CULVER'S JSP 23-37

PLAN REVIEW CENTER REPORT

Planning Review

Revised Preliminary Site Plan with Planned Development 2 Option, Special Land Use Request, and a Street Vacation Request

SCALE: 1'' = 20'NFE JOB NO.

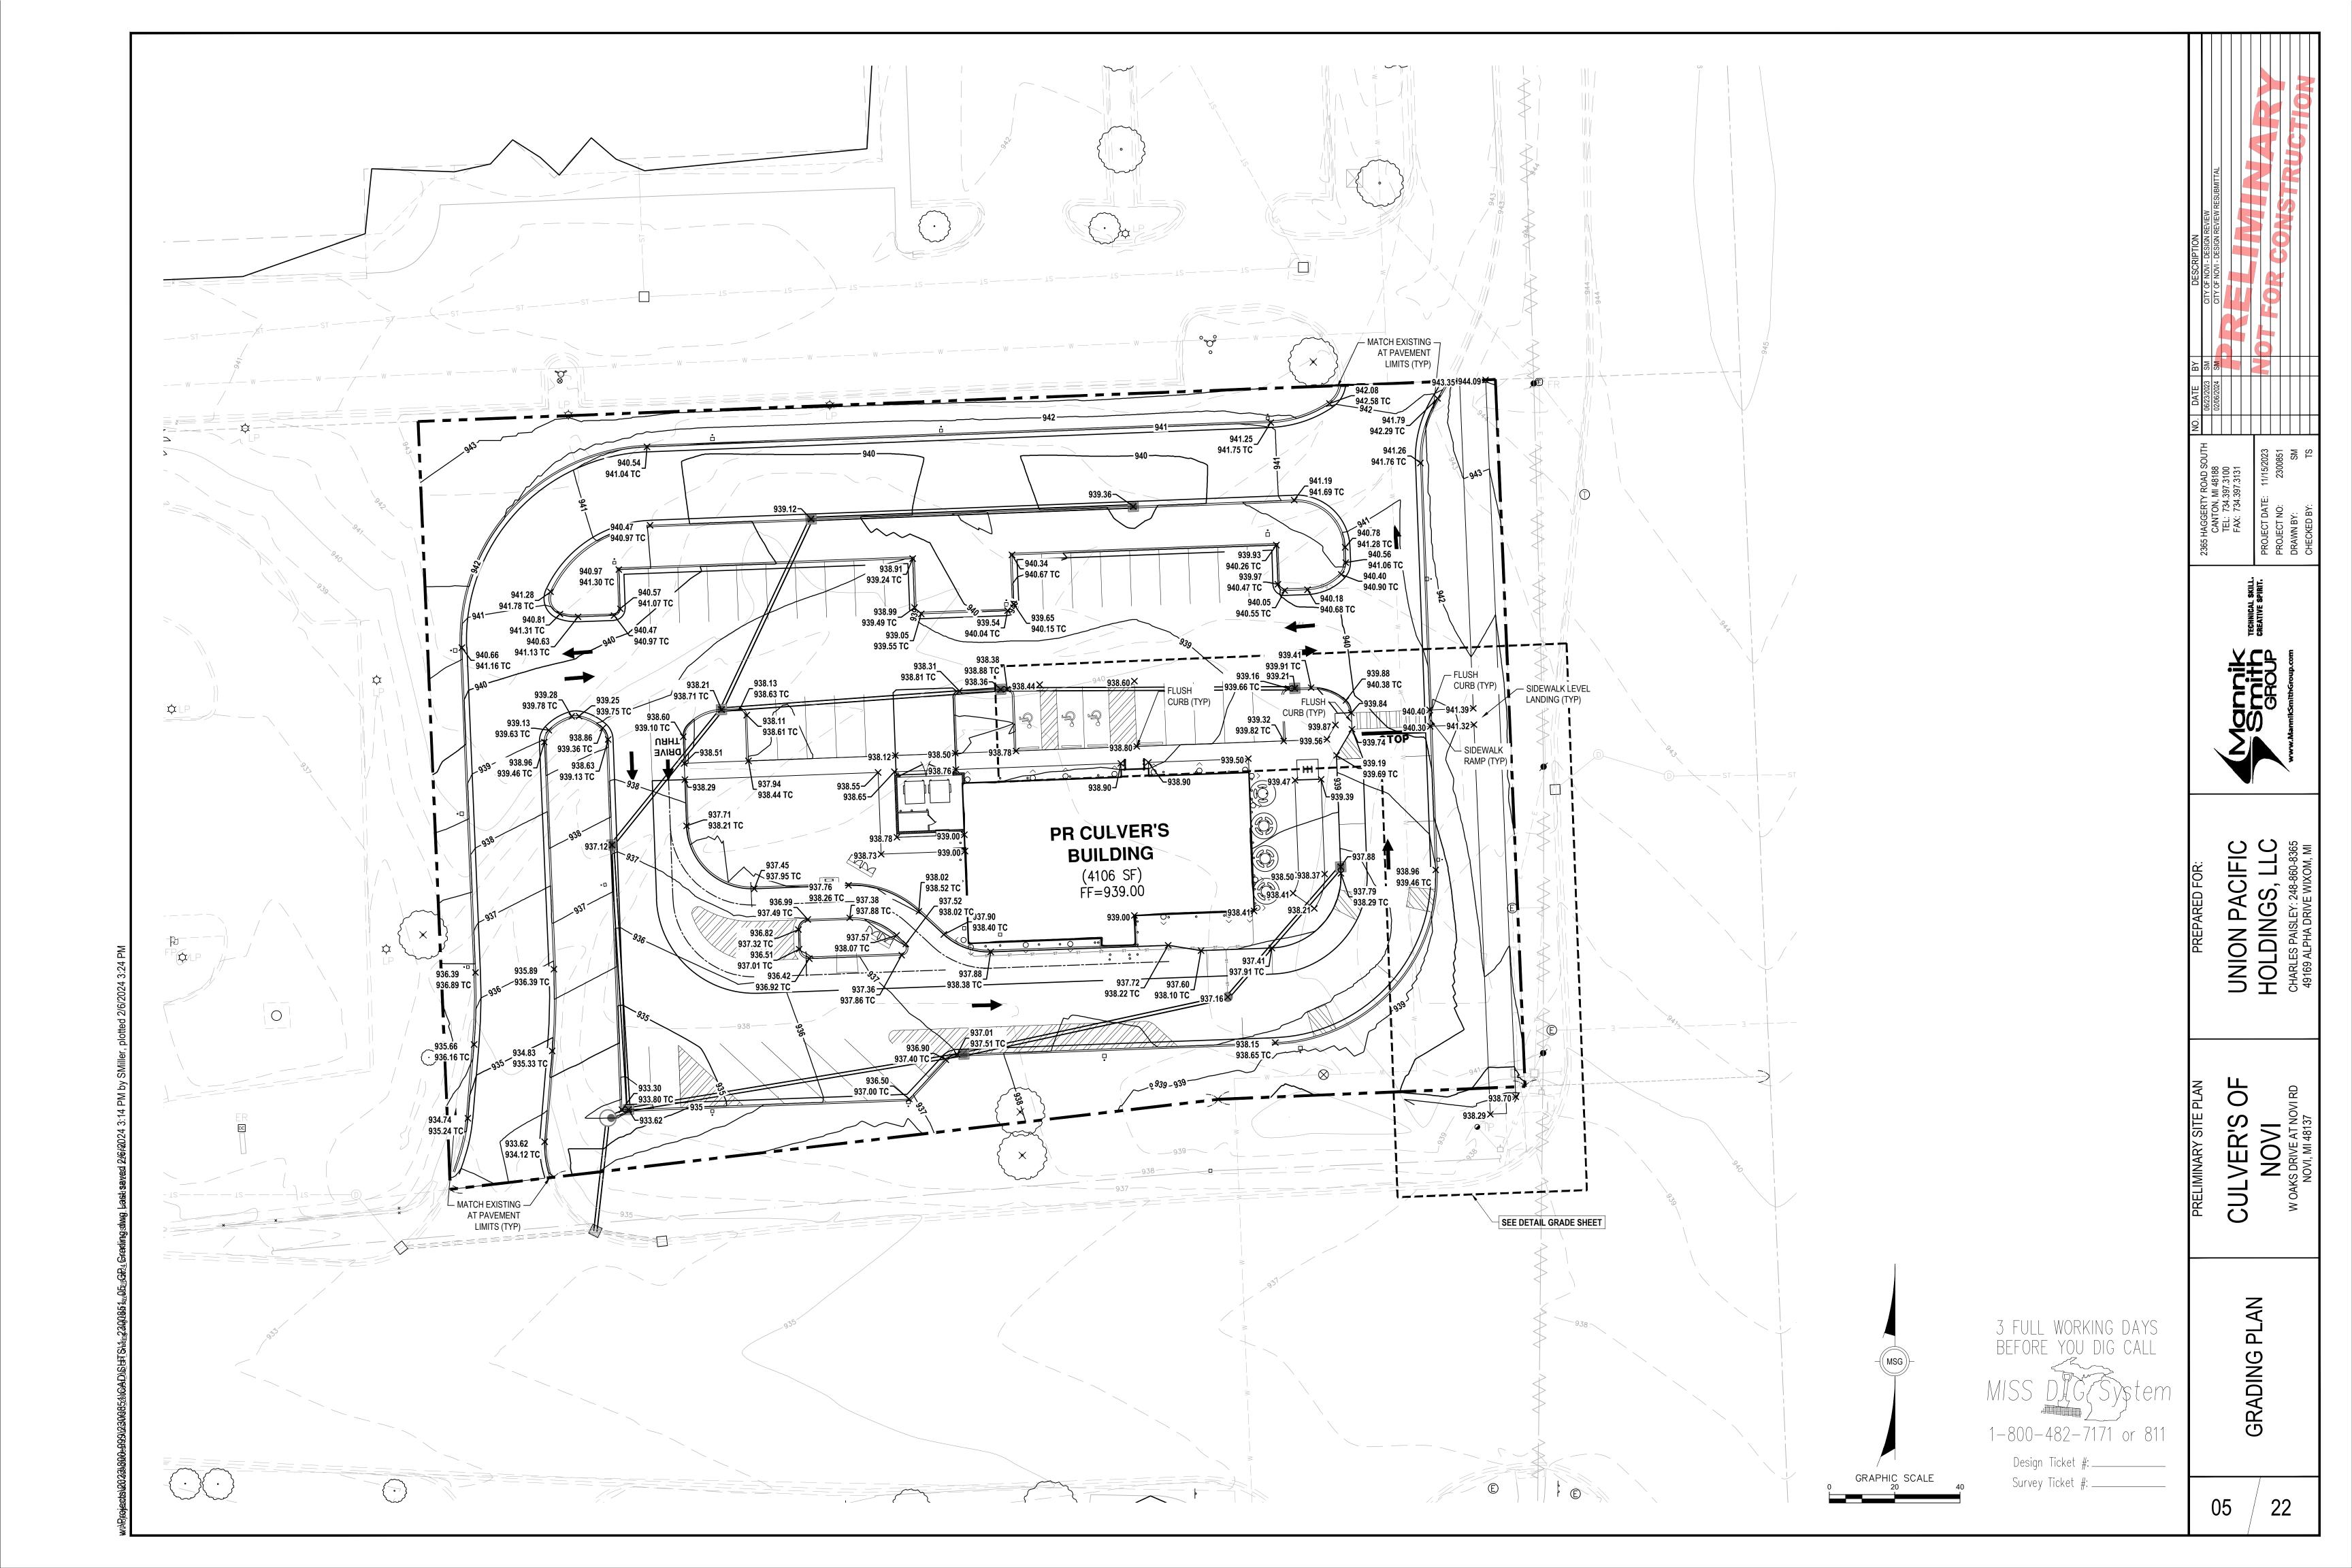
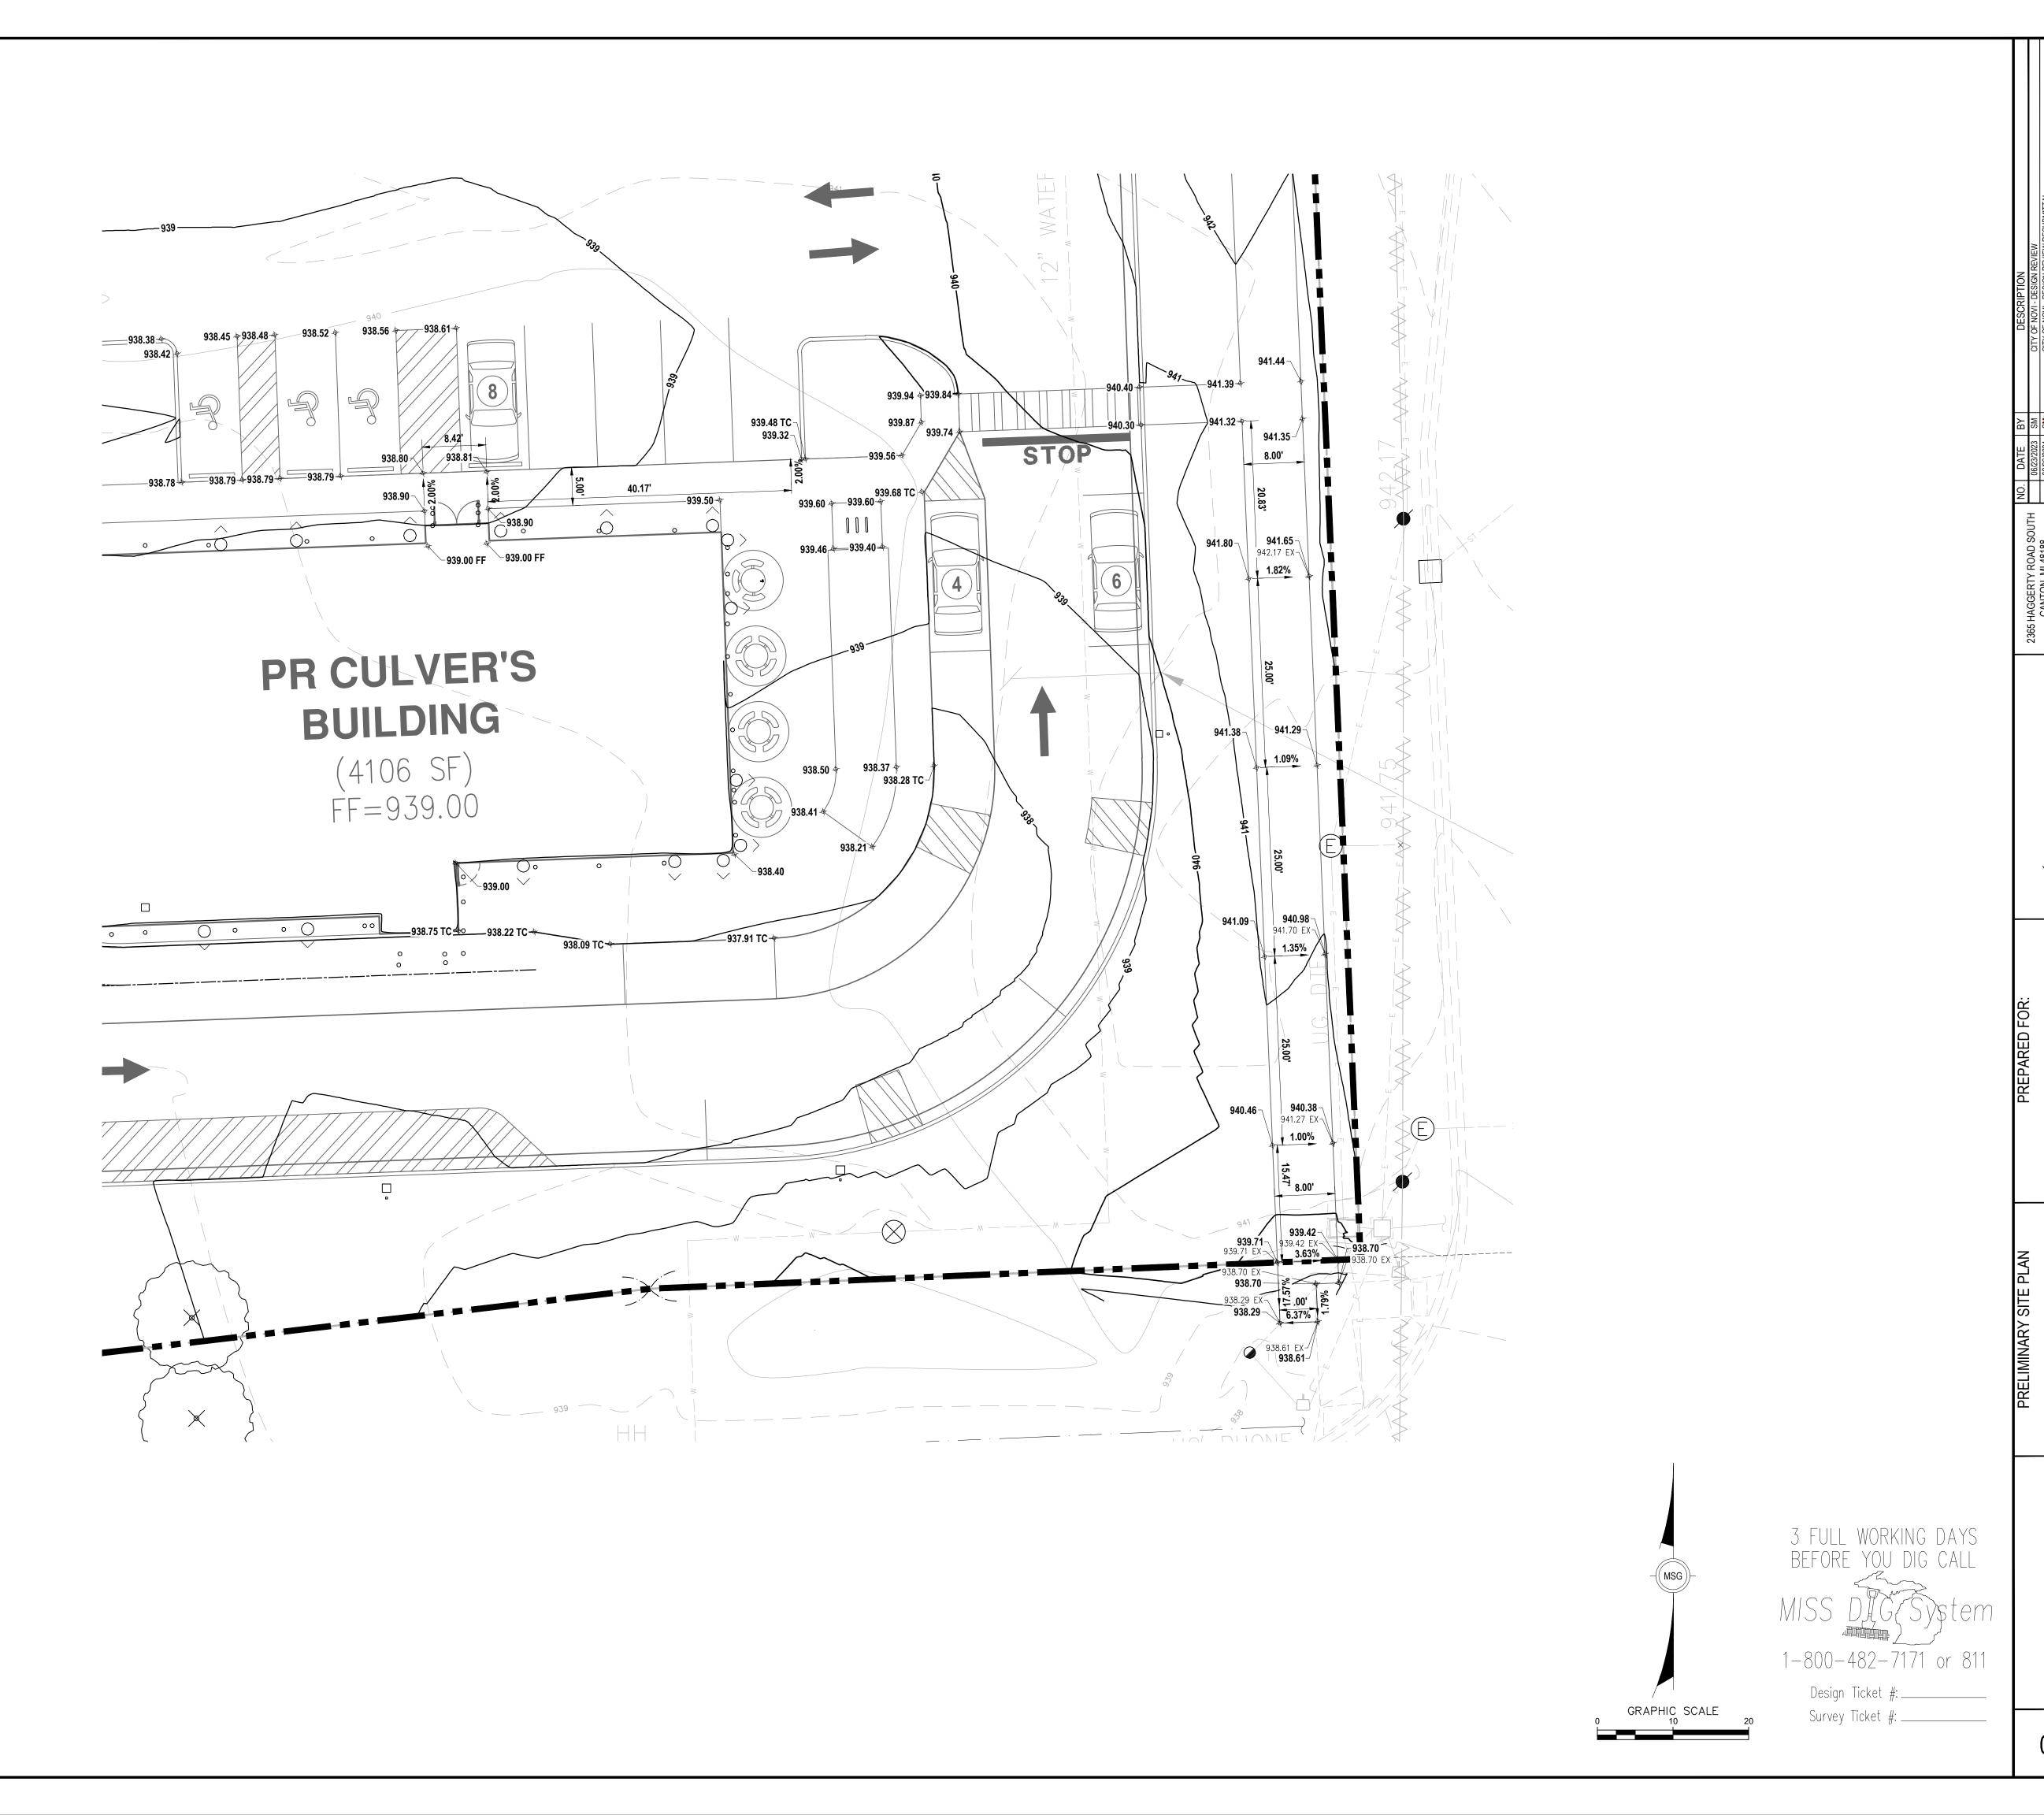
- 3. <u>Drive-thru Stacking Spaces (Sec. 5.3.11.1):</u> The distance between the order board and the pick-up window shall store four vehicles, and four vehicles shall be stored in advance of the menu board Please dimension the stacking spaces to show that 19 feet is provided per stacking space. See Traffic Review letter for further details.

- 4. <u>Drive-thru Bypass Lane (Sec. 5.3.11.D)</u>: Drive-through facilities shall provide one bypass lane to allow unobstructed travel for vehicles to pass those waiting to be served. Such bypass lane shall be a minimum of 18 feet in width, unless otherwise determined by the Fire Marshal. **The current bypass lane is 13 feet in width. This will need to be adjusted to comply with the Ordinance. The Fire Marshal is requesting that the bypass lane be 20 feet in width.**
